SERVICE BULLETIN

N° 189-345

ATA 63 - MGB ROD ASSY RETROMOD INSTALLATION

8G6330P00111
MGB ROD ASSY RETROMOD

Figure 1

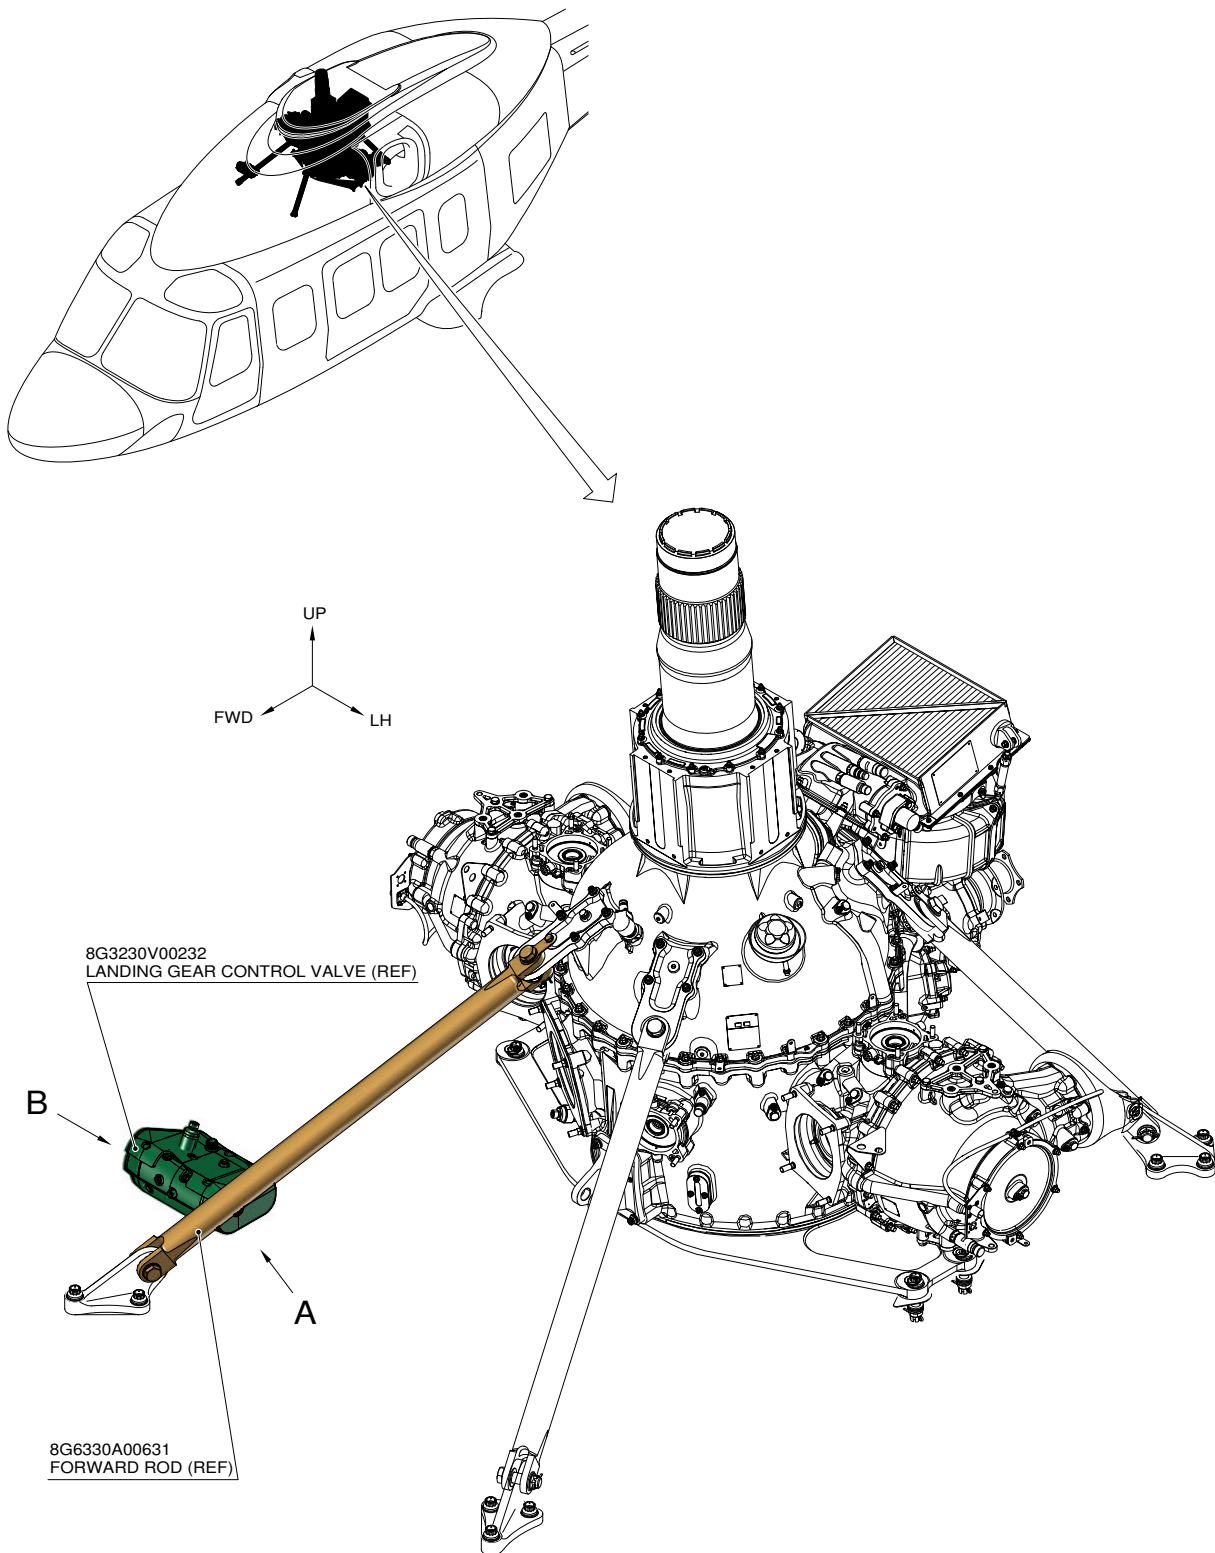
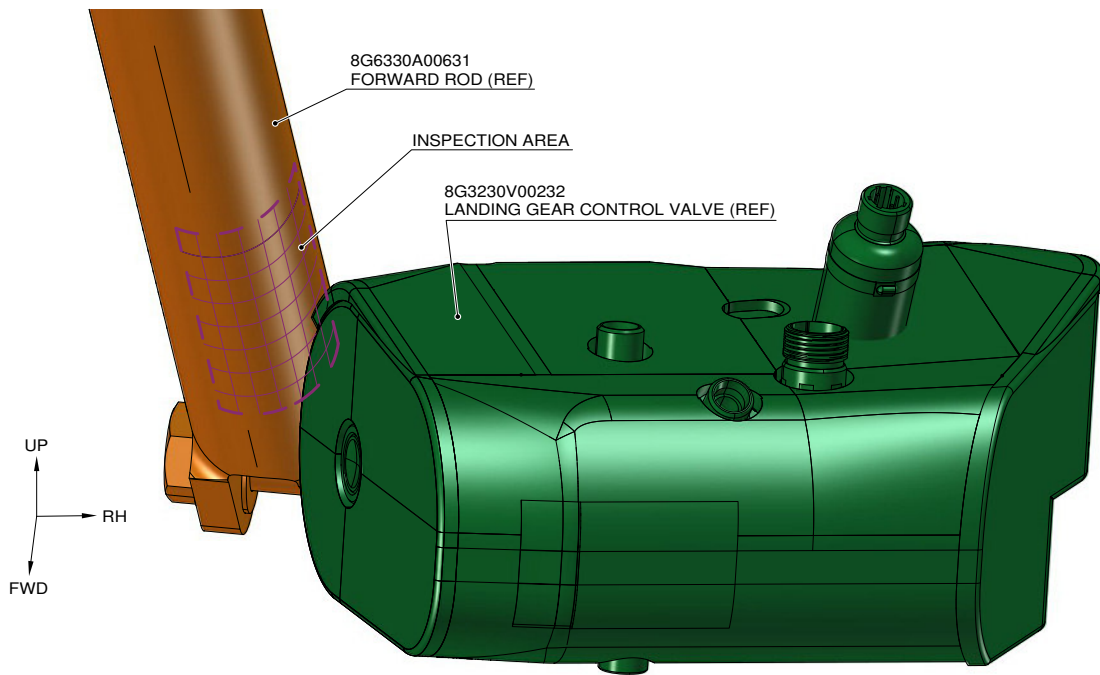
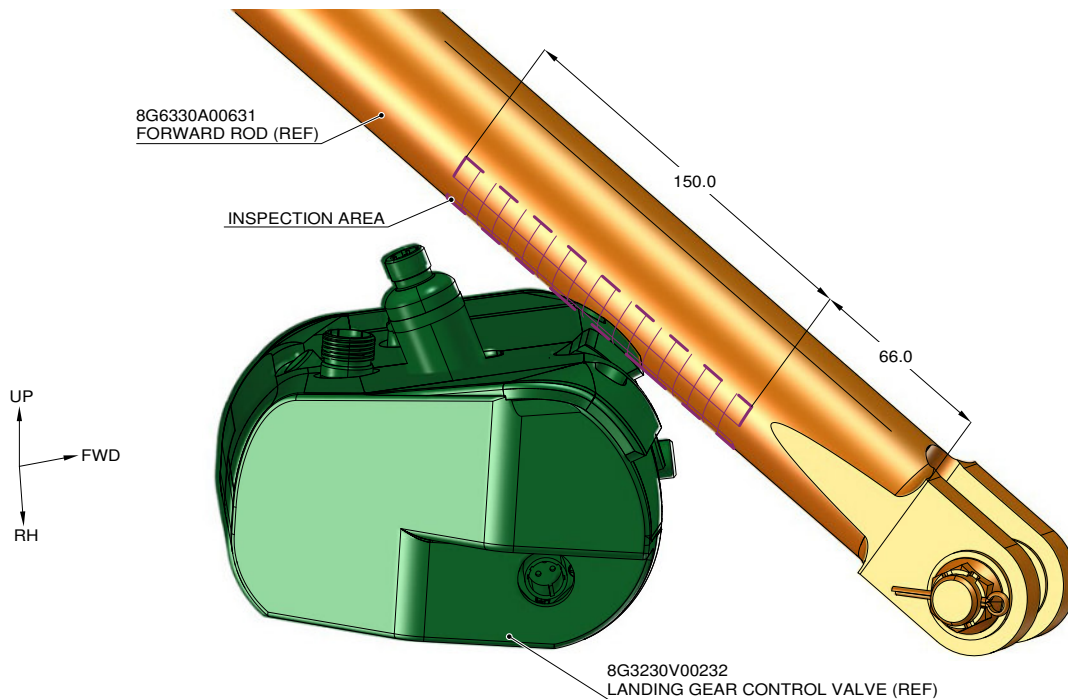
2. In accordance with AMP DM 89-A-06-41-00-00A-010A-A and with reference to Figure 1, open the access door 451A to gain access to the “MGB forward rod assy RH” P/N 8G6330A00631.

- 4.3 If the depth measured in the Step 4.2 exceeds 0.25 mm, perform the following procedure:
 - 4.3.1 In accordance with AMP DM 89-A-63-31-03-00A-520A-A and with reference to Figure 1, remove the “MGB forward rod assy RH” P/N 8G6330A00631.

- 4.3.2 In accordance with AMP DM 89-A-63-31-03-00A-720A-A and with reference to Figure 1, install a new rod P/N 8G6330A00631 by means of the previously removed hardware. Skip to Step 5.

Figure 2

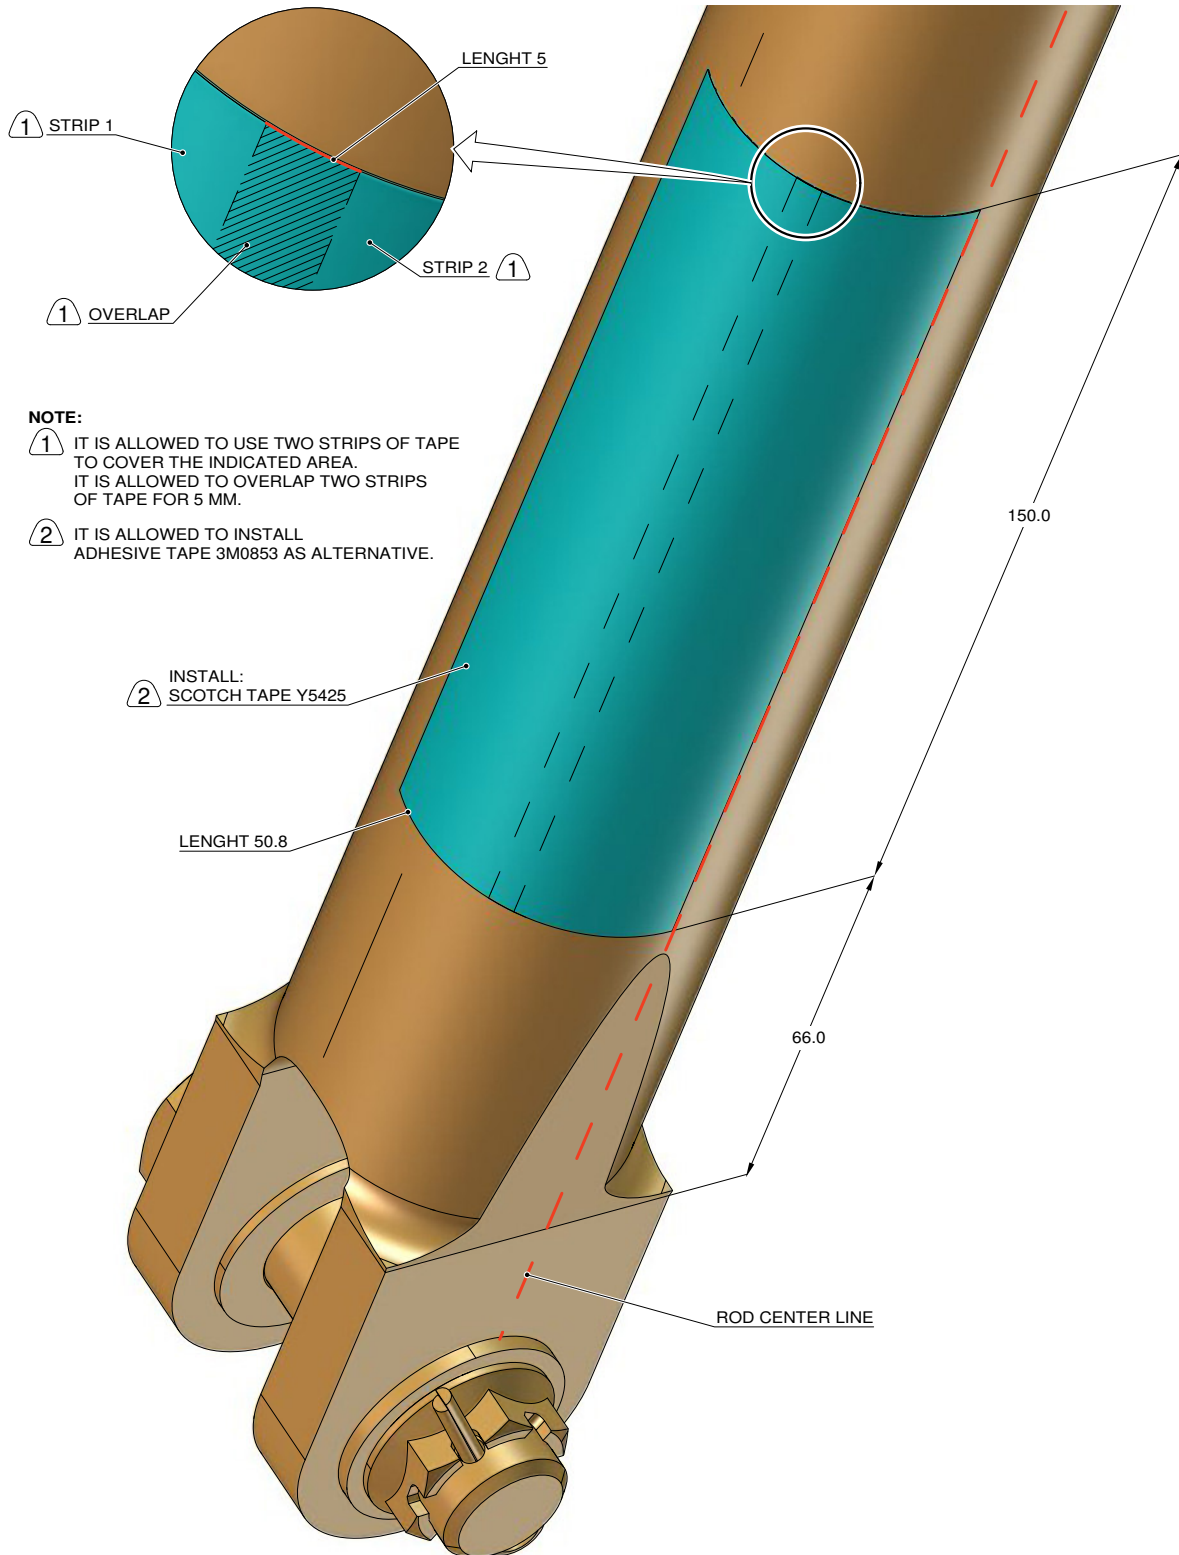
3. With reference to Figure 2, visually inspect the indicated area for evidence of wear or damage on the “MGB forward rod assy RH” P/N 8G6330A00631. If necessary, use a mirror and a source of light to completely inspect the area. If no damage is present, skip to Step 5.

4. In case of findings, perform the following procedures:
 - 4.1 Take a picture of the damage and of the LGCV installed (including the cover). Send the pictures to Leonardo Engineering Dept. at the following mail box: engineering.support.lhd@leonardo.com.

- 4.2 Measure the depth of the wear or damage in the MGB rod (do not consider the thickness of paint/primer). Note the value in the Inspection Report in Figure 4.

- 4.4 If the depth measured in the Step 4.2 is less than 0.25 mm, touch-up the exposed areas of the repaired zones with primer and paint to restore the original aspect of the MGB road in the damaged area, then proceed with Step 5.
